Title		
Size	Number	Revision
A		
Date:	1/14/2016	Sheet of
File:	C:\Users\...\Power.SchDoc	Drawn By:

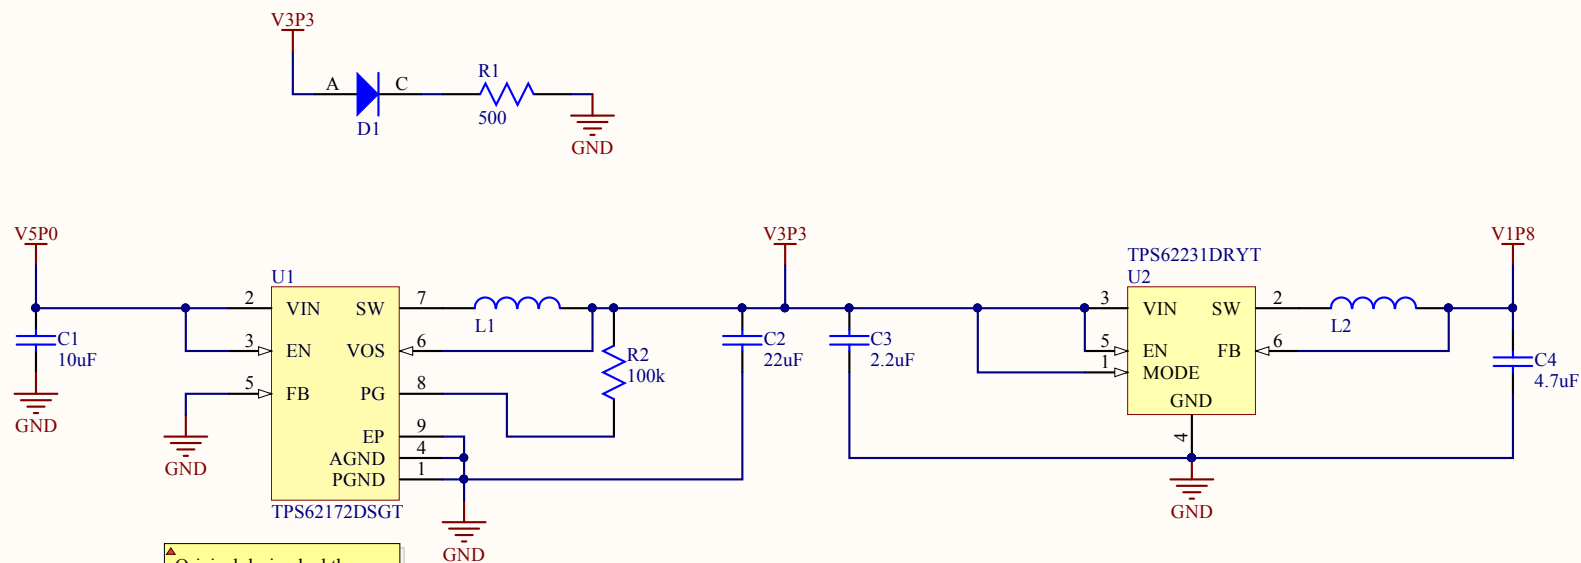
▲ Original design had the TPS62170 which was incorrect. Make sure BOM has the fixed 3.3V output version.
